STATE OF OREGON DEPARTMENT OF ENVIRONMENTAL QUALITY

PERMIT NO. 97-19

TYPE OF SYSTEM Alternative-Bottomless Sand Filter

RE: PLAN APPROVAL FOR PERMIT ISSUANCE

**CONCRETE CONTAINER BOX DETAIL
 FOR RESIDENTIAL SEPTIC SYSTEM**

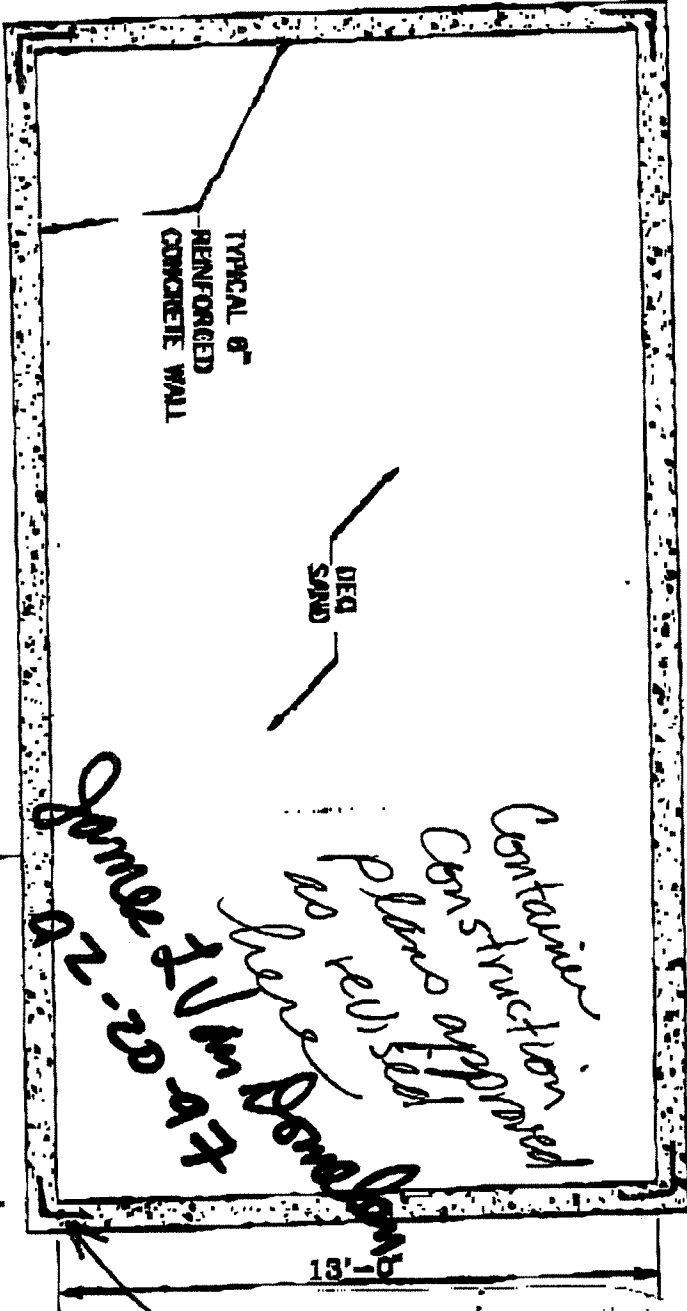
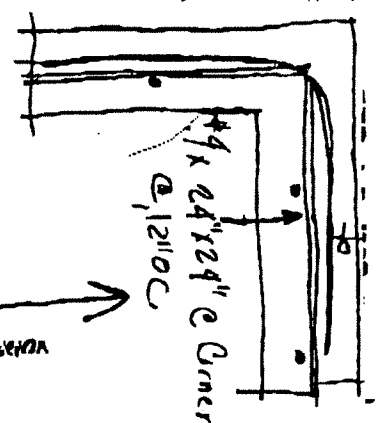
*Container Construction
 per structural
 plans approved
 by JLD
 No fence or
 concrete pad
 Reinforced?*

*All corners must
 be reinforced
 See Detail*

CONSTRUCT THE CONCRETE CONTAINER IN COMPLIANCE WITH THE PLANS AS REVISED AND APPROVED BY DEQ ON 2-20-97.

FLOOR PLAN
SCALE: 1/4" = 1'-0"

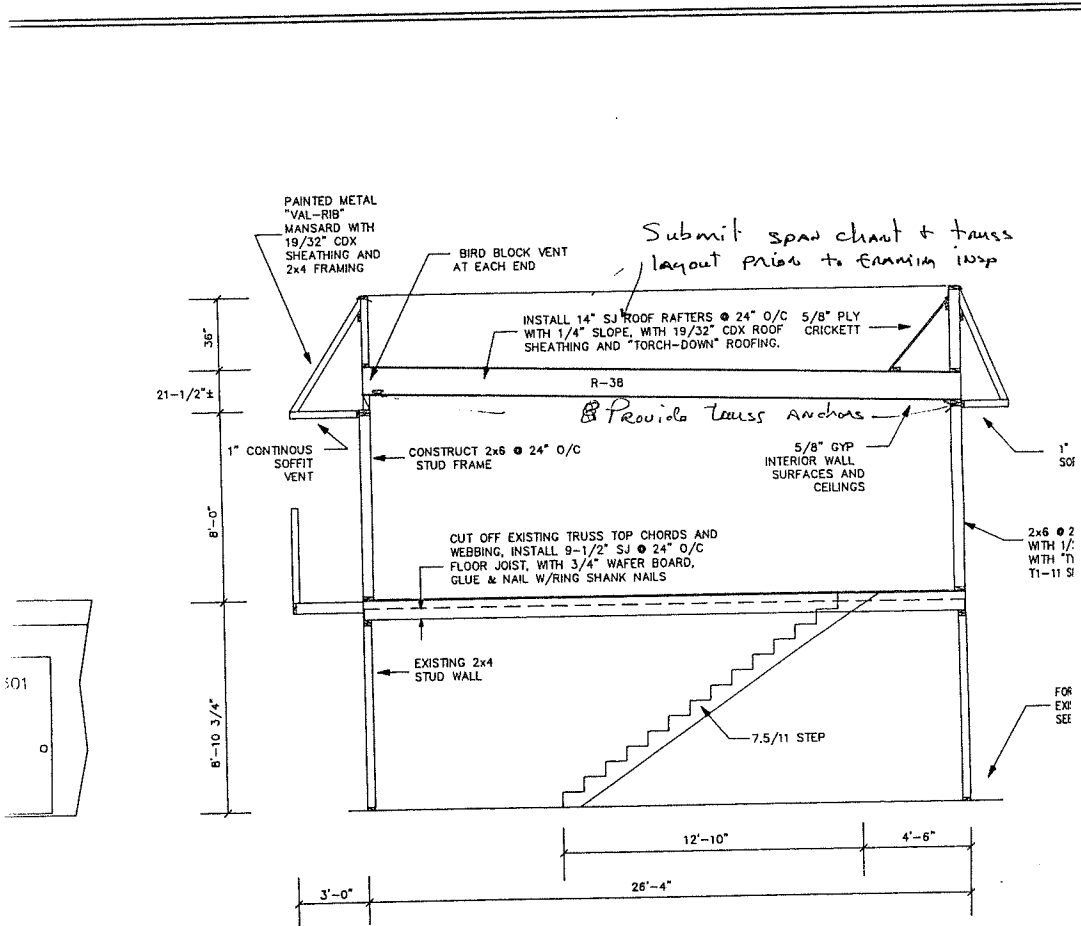
Submit span chart & truss layout prior to framing insp

SECTION VIEW

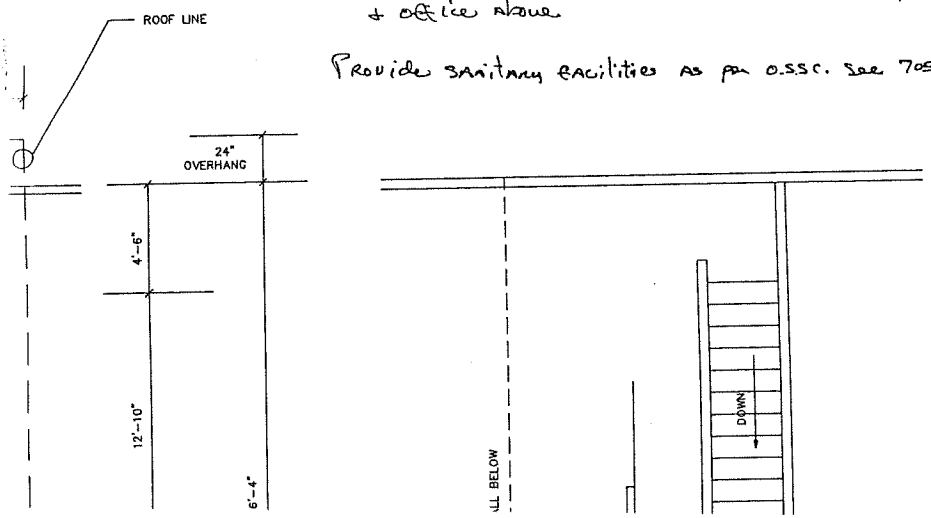
Provide truss anchors

Provide 1 hr separation between dwelling & office above

Provide sanitary facilities as per O.S.S.C. see 705 (c)
